SAFETY RECALL NOTICE

CERTAIN SMITH & WESSON MODEL SW1911 PISTOLS BEARING SERIAL NOS. JRD0000 TO JRD4750 CONTAIN A FIRING PIN SAFETY PLUNGER THAT MAY BECOME DISABLED DURING OPERATION COMPROMISING THE PERFORMANCE OF THE FIREARM AND ITS SAFETY SYSTEM. YOU SHOULD STOP USING THE PISTOL AND RETURN IT TO SMITH & WESSON SO THAT AN IMPROVED FIRING PIN SAFETY PLUNGER CAN BE INCORPORATED INTO YOUR HANDGUN.

FIGURE 2

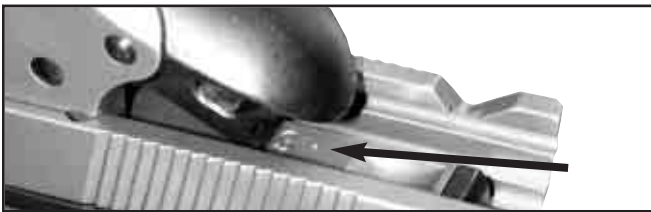
WE HAVE ALREADY BEGUN THE CORRECTIVE ACTION PROCESS ON SW1911 MODELS. TO DETERMINE IF YOUR SW1911 HAS BEEN CORRECTED, PLEASE DO THE FOLLOWING: 1. REMOVE THE MAGAZINE AND BE SURE YOUR FIREARM IS UNLOADED. 2. LOCK THE SLIDE TO THE REAR AND LOOK ON THE BOTTOM OF THE SLIDE FOR A "PUNCH DOT" MARK NEXT TO THE LETTER S (FIG. 1). 3. CHECK THE FIREARM BOX END LABEL FOR A RED "SP" STAMP. (FIG. 2). IF THESE TWO INDICATORS ARE PRESENT, YOUR SW1911 PISTOL HAS ALREADY BEEN MODIFIED AND NO FURTHER ACTION IS REQUIRED.
